To: Selwyn District Council
From: Hugh Nicholson, Urban Designer
Date: 17th January 2022
Re: Plan Change 71 Rolleston – Urban Design and Landscape Review

- 1.2 I have been asked by the Selwyn District Council to carry out a peer review of the *Urban Design Statement* (dated 9/11/2020) and the *RFI – Landscape matters and visual assessment* (revised 10/05/2021) provided by a+urban. Where necessary I have provided additional comments on urban design effects in relation to the urban form of Rolleston, and commented on matters raised in submissions that relate to urban design or landscape architecture.

**Figure 2: PC71 ODP - Rolleston
(with CIAL 50dBA noise contour)**

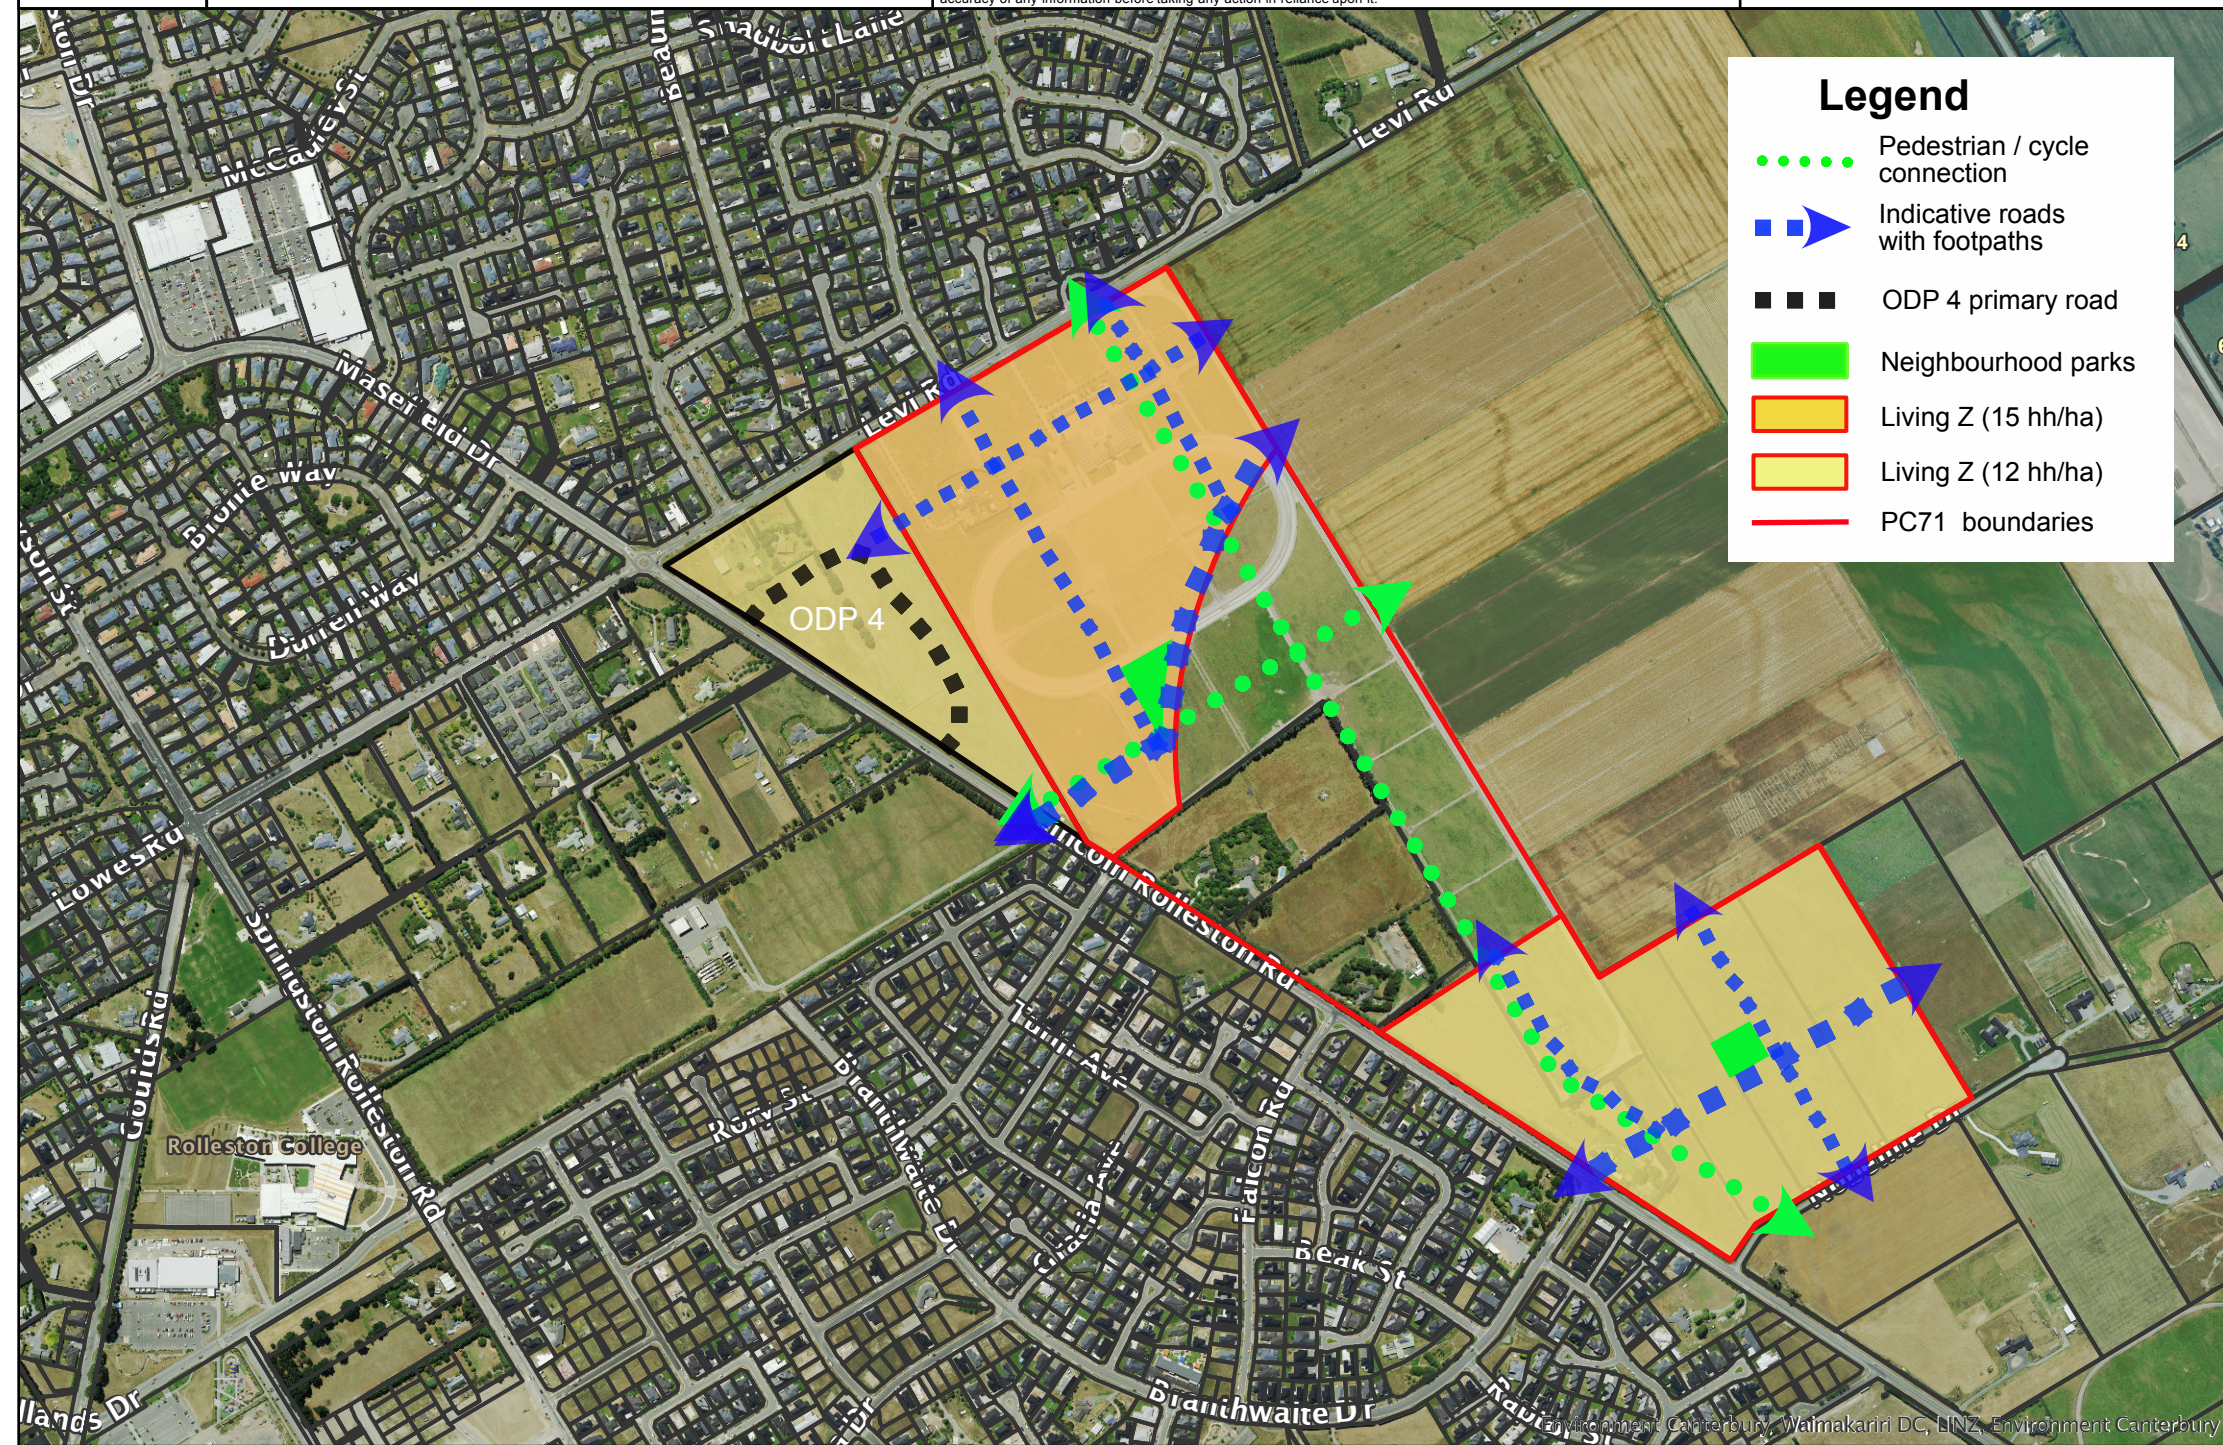
- 3.2 In particular I have recommended a simpler grid network of streets in the northern and southern parts of the plan change area and recommended moving the neighbourhood reserves into the centre of these areas so that they can stand alone if the 50 dBA airport noise contour is not removed (see Figure 2). I have recommended a second connection onto Levis Road but I note that this is subject to discussion with Mr Collins regarding potential traffic effects.

- 3.3 In my opinion two road connections through ODP4 are necessary to provide an adequate level of connection between the northern half of PC71 and the wider Rolleston township. I recommend that the ODP narrative is amended to ensure that these connections are constructed prior to or at the same time as the subdivision of the northern half.

- 6.3 I have recommended changes to the ODP (and associated narrative) including⁴:
- a. A simpler grid network of streets in the northern and southern parts of the plan change area and moving the neighbourhood reserves into the centre of these areas so that they can stand alone if the 50 dBA airport noise contour is not removed (see Figure 2). The grid is extended into the full area if the 50dBA airport noise contour is removed (see Figure 3);

- d. Changes to ODP4 including a minimum of two connections from PC71 to Lincoln Rolleston Road (see Figures 2 and 3). If scope permits, upzoning the strip of land zoned low density (1,000m² +) on the eastern boundary to a minimum net density of 15hh/ha, and the explicit provision of a shared pedestrian / cycle path as part of the upgrades of the Lincoln Rolleston and Levis Road frontages.
